PRODUCT INFORMATION BULLETIN

SUBJECT: Oil Filter Adapter Kit Part #96226

MODELS AFFECTED: GN 191/220 Engines

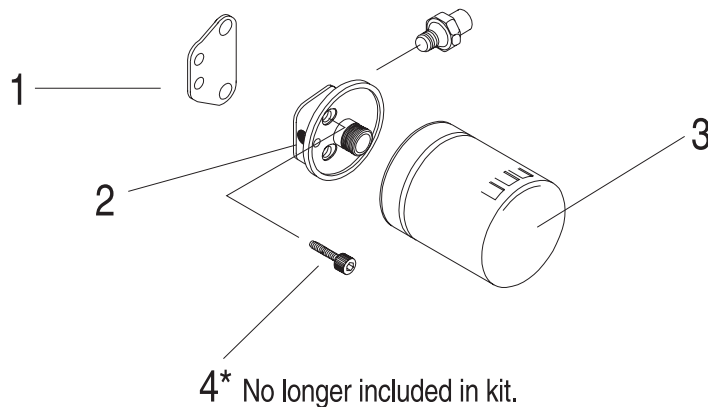
PROBLEM: Incorrect screws in kit

CORRECTIVE ACTION: Remove and discard screws from the kit (Item #4*). **Use original screws from the old block off plate to attach oil filter kit adapter.** This will be standard procedure as the screws will no longer be included in the kit.
